UZBEKISTAN GAS TO LIQUID PROJECT (UZGTL)

HAZOP ACTION CLOSE-OUT REGISTER FOR MAKE-UP H2 COMPRESSOR PACKAGE

UZGTL-HDC-HSE-RP-50-0-0004

NOTES

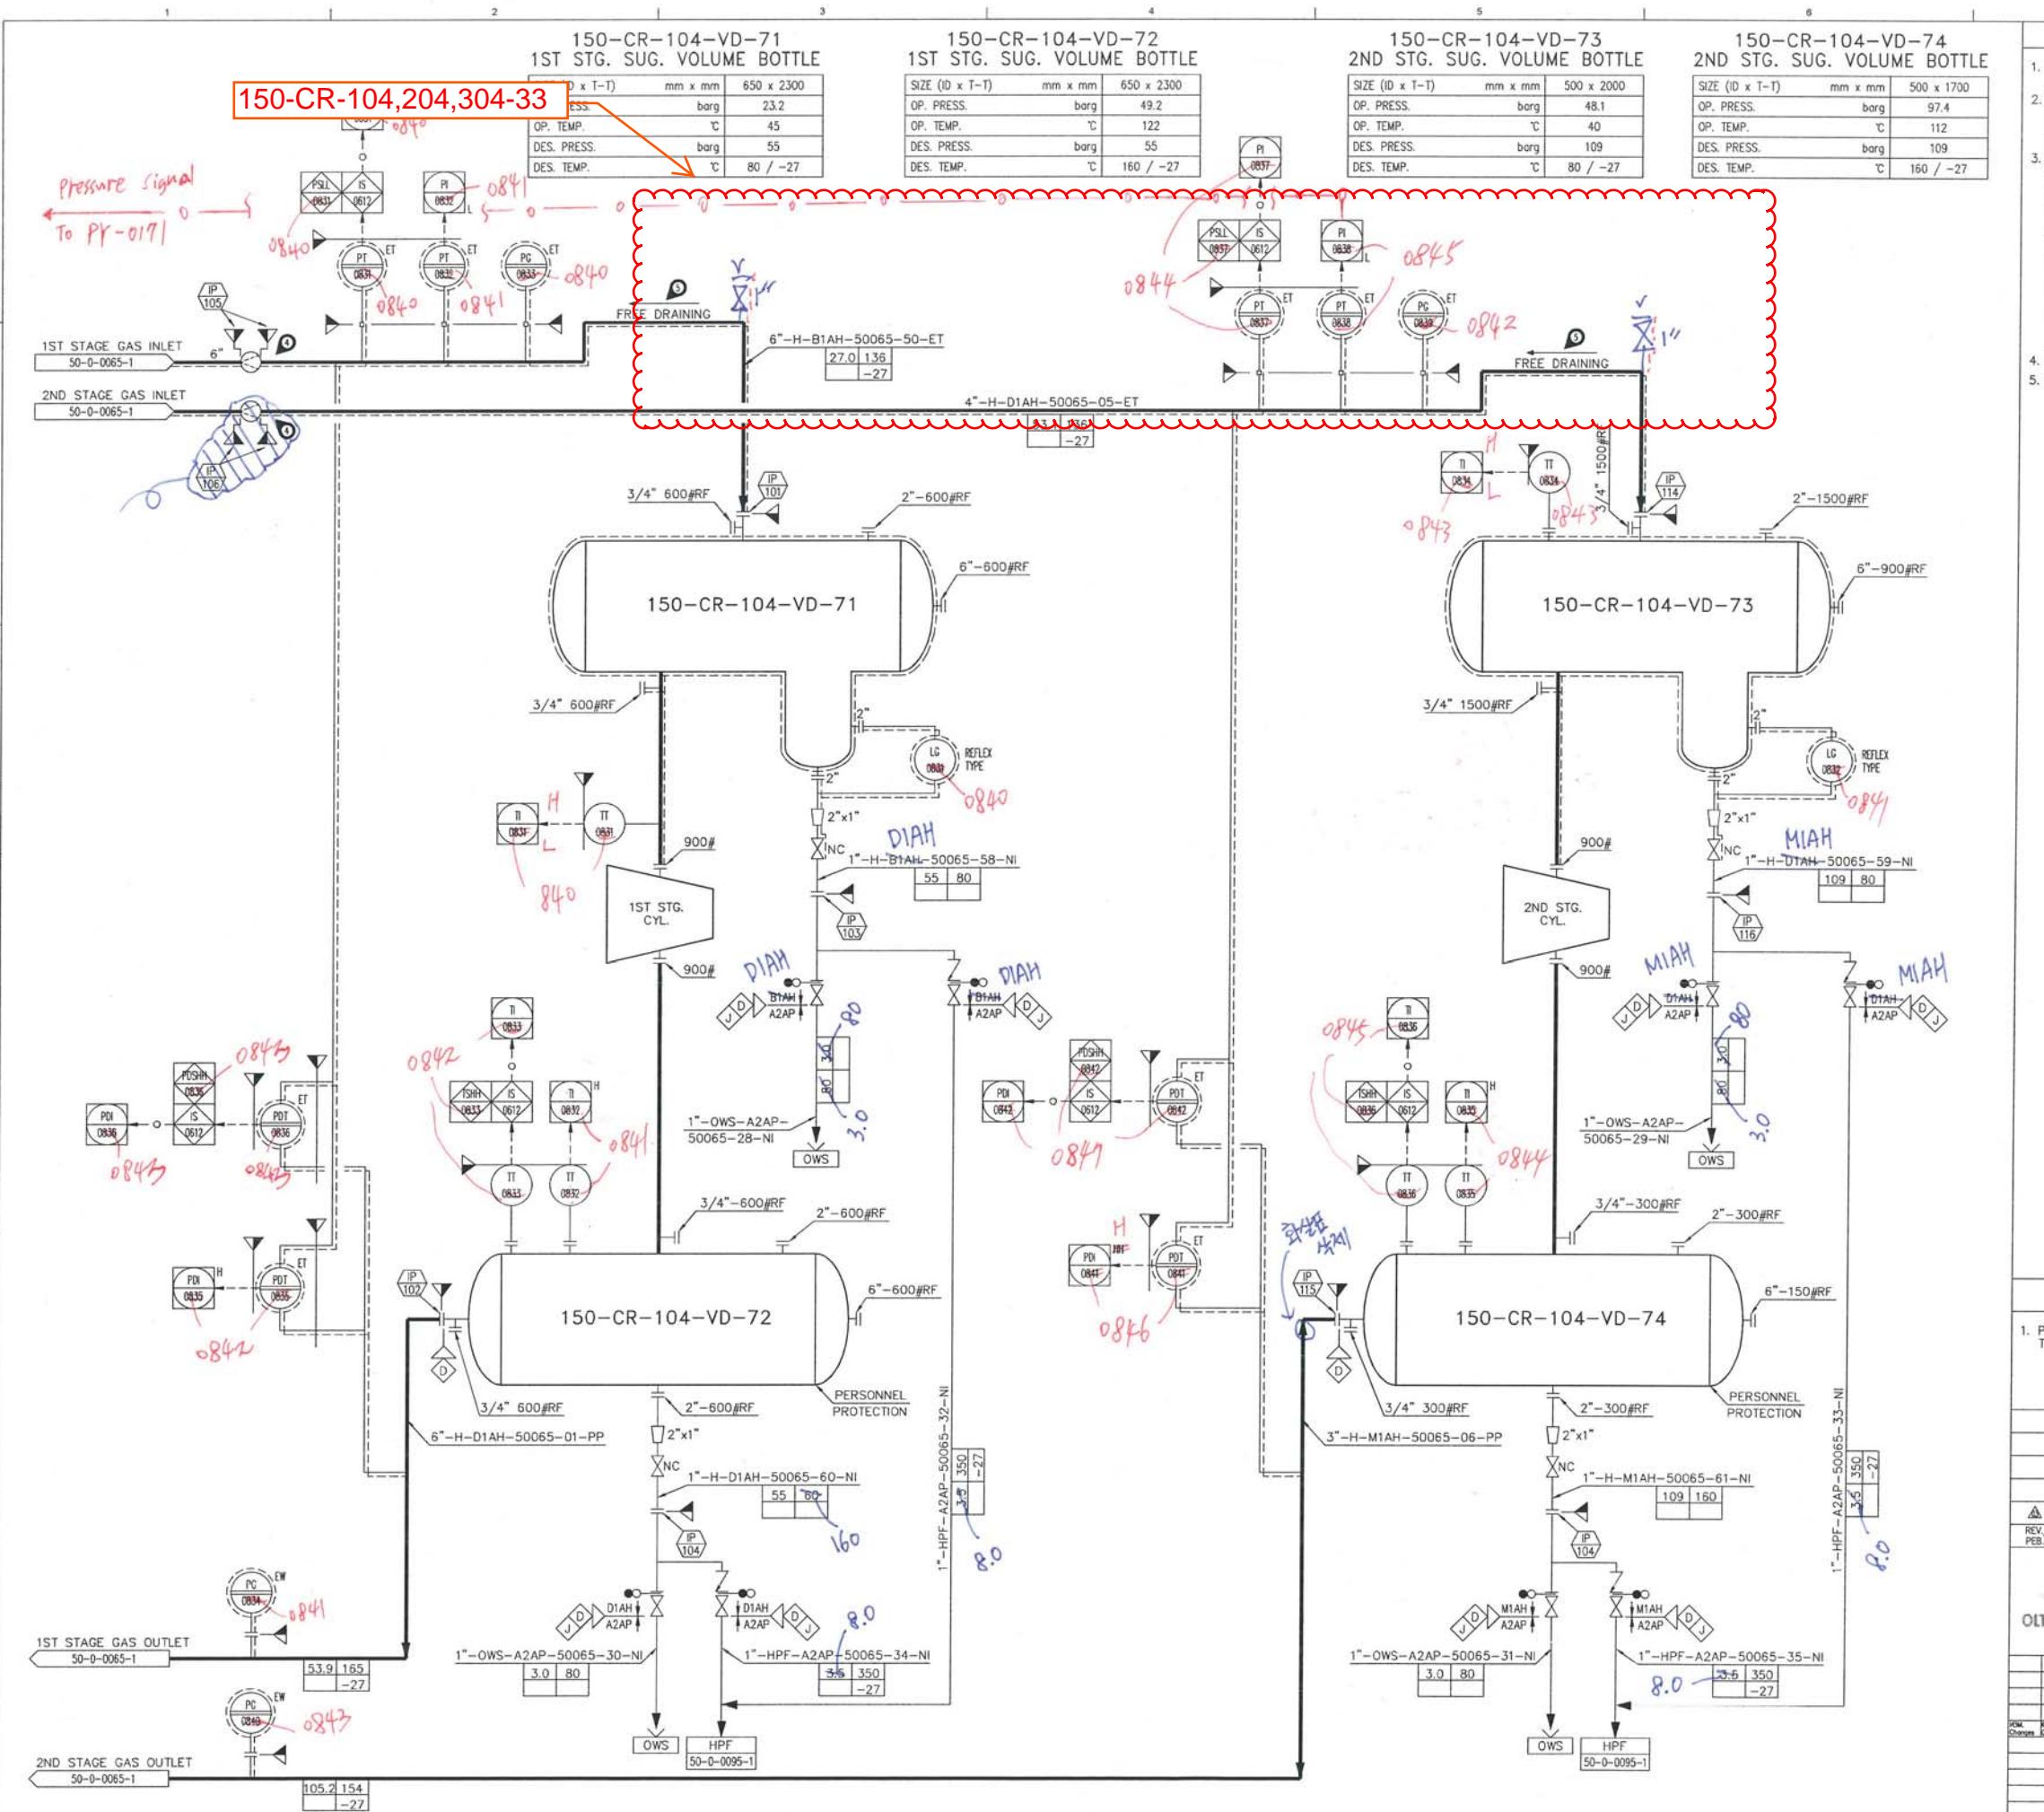
Action No.	150-CR-104/204/304-30				
Action By	PR				
Node No.	1				
Node Description	1. Compressor Process Gas / Compressor Vent & Drain / Compressor Unloader				
Cause	1.17.3. Compressor capacity load control malfunction during start-up with N2 run				
Consequence	1.17.3.2. In case of incorrect line up, potential overpressure could affect upstream piping and equipment				
Safeguards	1.17.3.2.1. 150-PCV-0284 (Pressure regulator on N2 line)				
Action	Provide check valve on H2 make-up line from Unit 60 (downstream isolation valve at BL)				
Response	Since the dissimilar type double check valves are installed on the H2 make-up line of Unit 60 (60-0-0012-1), the check valve will not be installed on the H2 make-up line of unit 50 line.				
CONTRACTOR			OWNER		
Position	Signature	Date	Position	Signature	Date
Process Engineer	<u>B.M.Hwang</u> 	10-Apr-2018		_____
